Procurement Department
IFB: Academic Restroom Upgrades Project – Phase 1
Project SU-111720
Addendum #1 * December 18, 2020

Purchase College Project #SU-111720
Academic Restroom Upgrades – Phase 1

Addendum #01 - Bidder's Questions & Answers

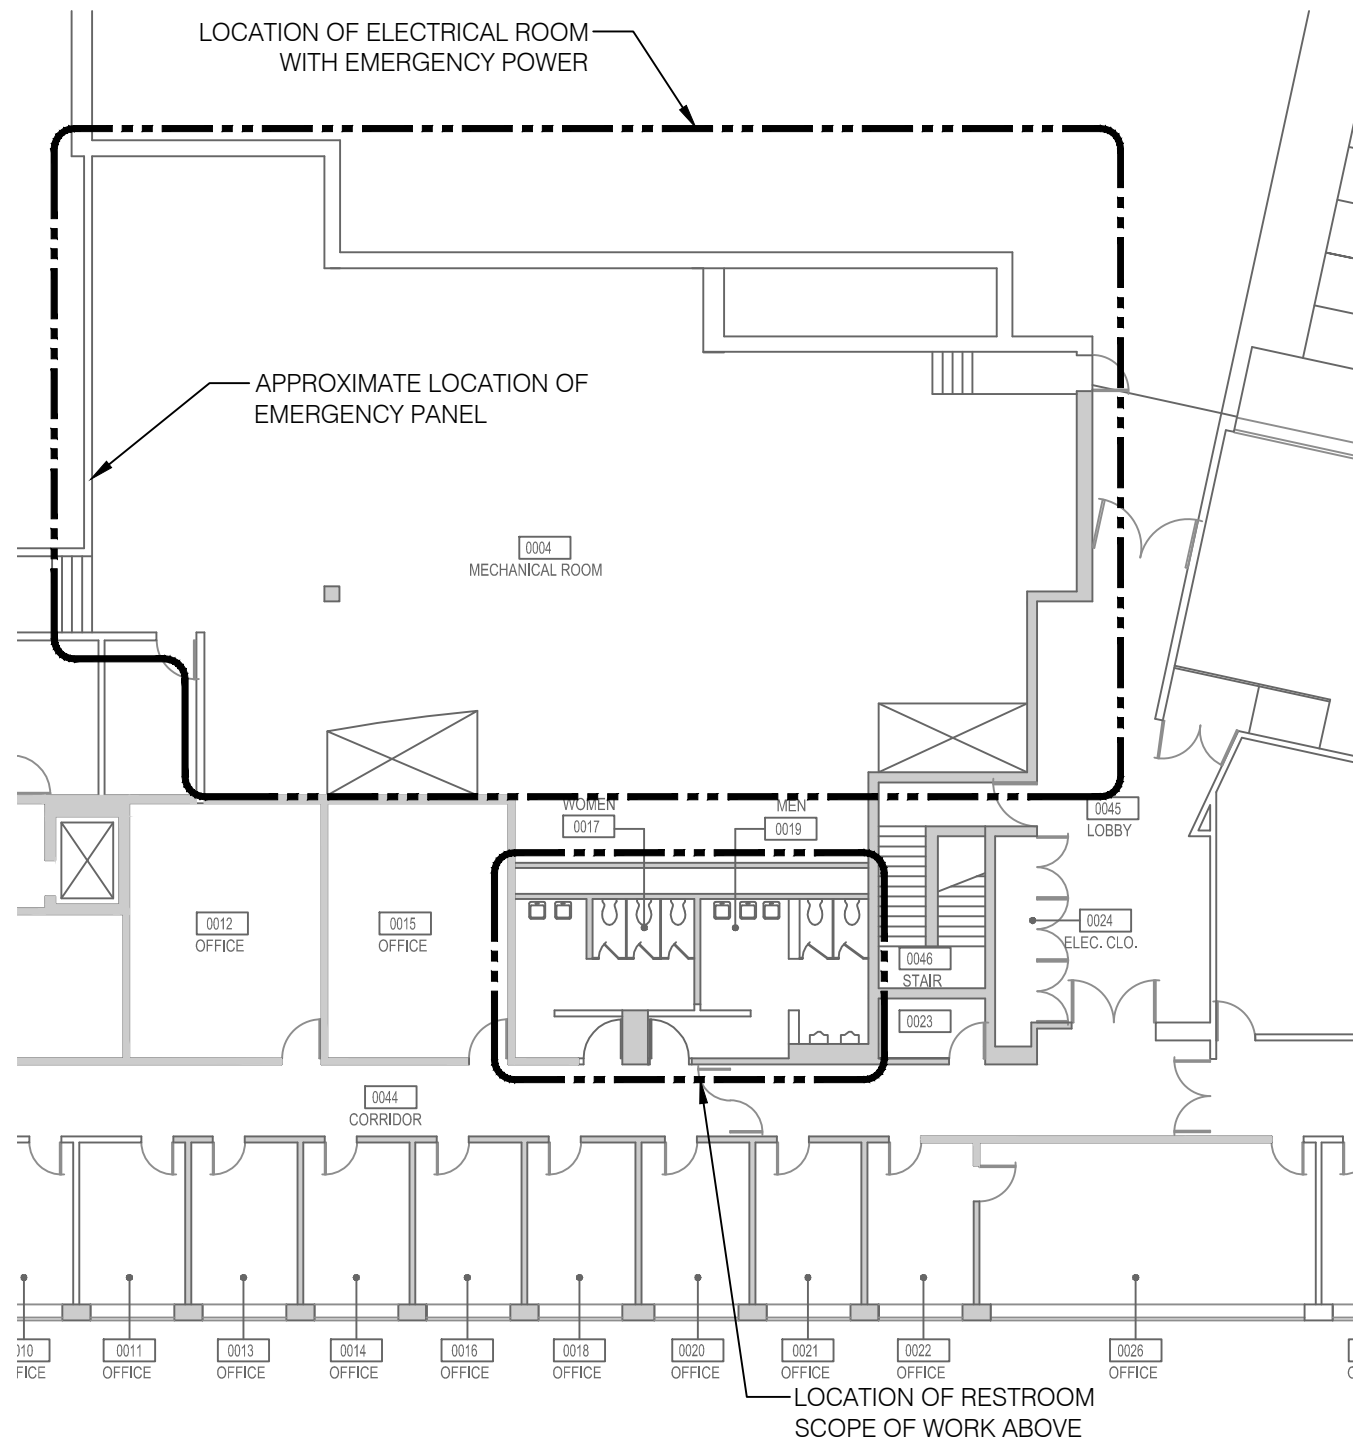
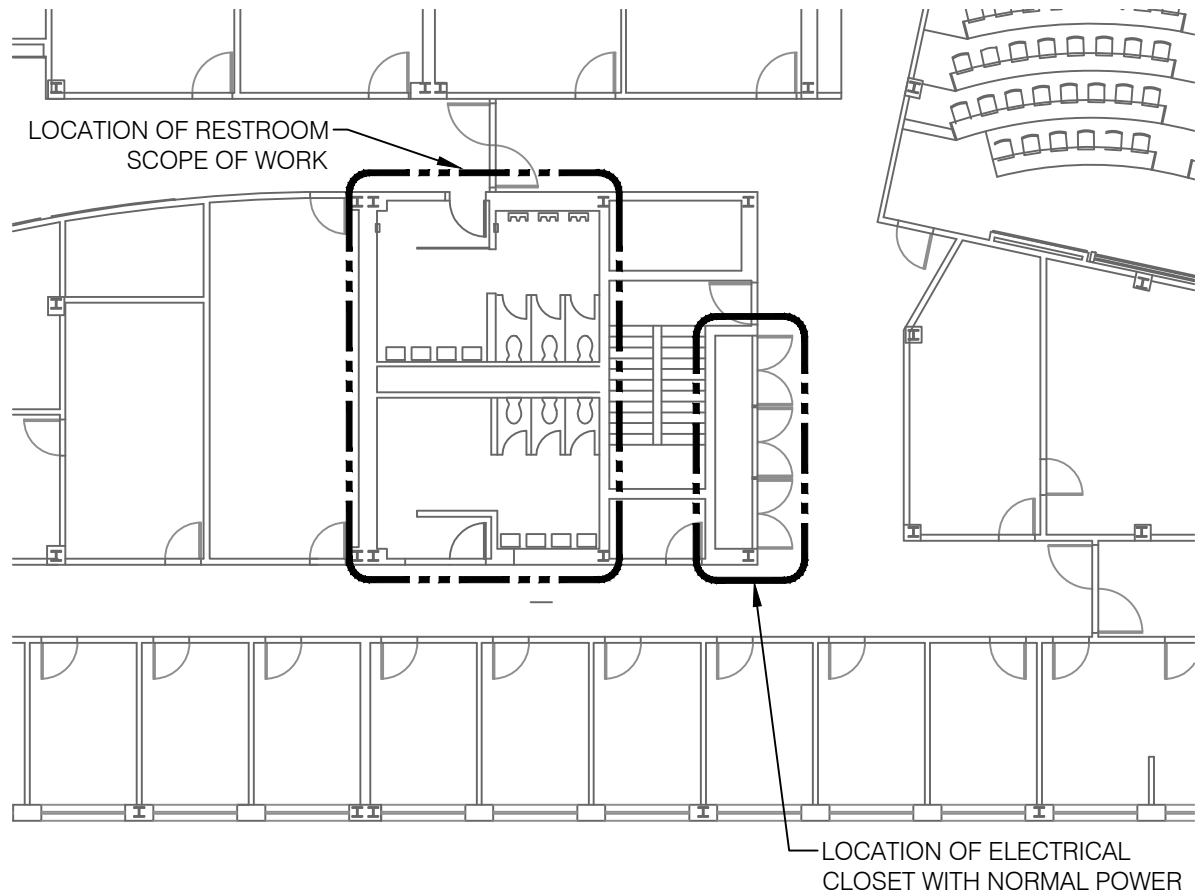
- Q14. Can you provide the correct manufacturer and part No. for type "L5" fixture? It is listed as Tango, but their representative is stating it is not a valid part number. I

searched the fixture online and came up with George Kovaces Fixtures, but their representative also said the part number is invalid.

A14. Refer to Architectural drawings for light fixture schedules.

SK.E.01

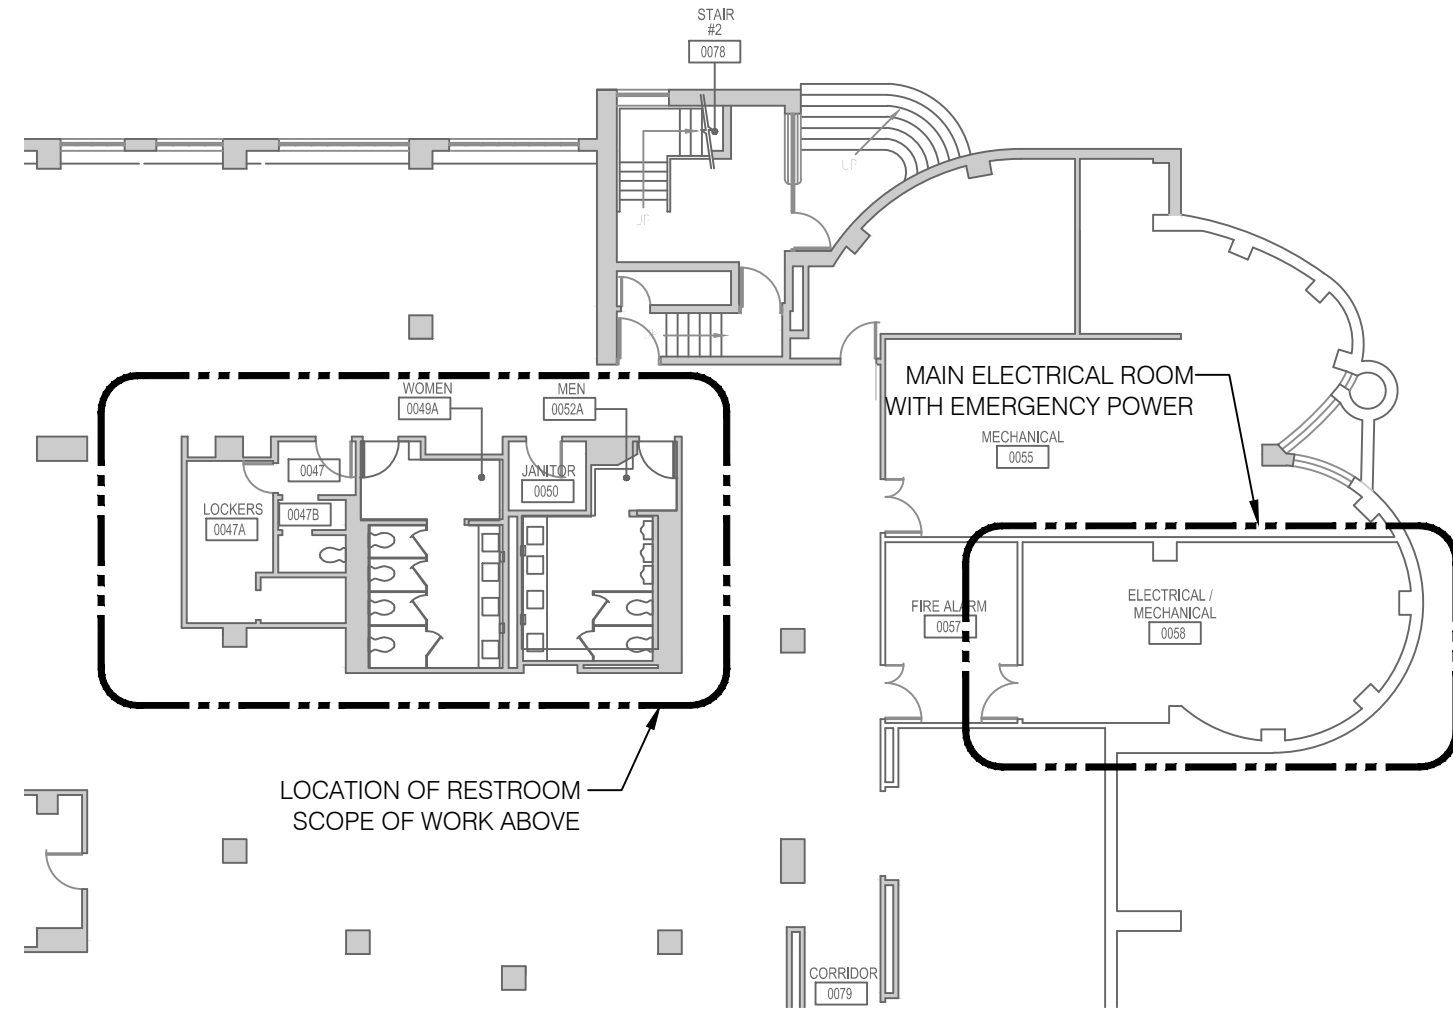
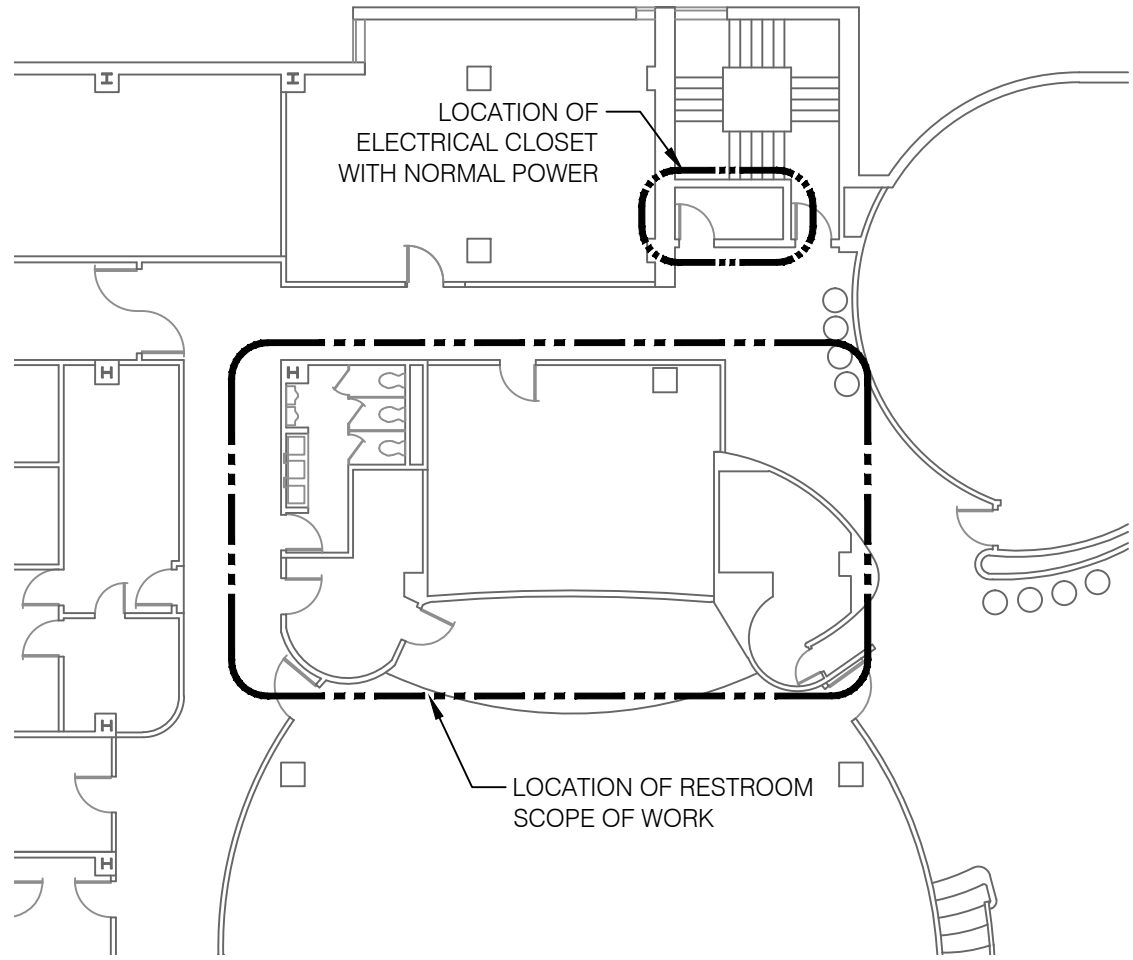
- A9. Unit price will not be required for this project,**
- Q10. Is the GC supplying the toilet fixtures?
- A10. Yes.**
- Q11. Provide a floor plan depicting the location of the Electric Closets associated with the branch circuits for normal and emergency circuit breaker panels.

- A11. Key Floor Plans would be provided that would depict the location of the electrical closets associated with the branch circuits for. There would be a total of four key plans showing the used electrical closets. Refer SK.E.01 and SK.E.02 for the key plans. Additionally, panel H1S is located in electrical closet 1061 and not in basement electrical closet 045 as stated in the panel schedule. This will be corrected in the addendum set.**
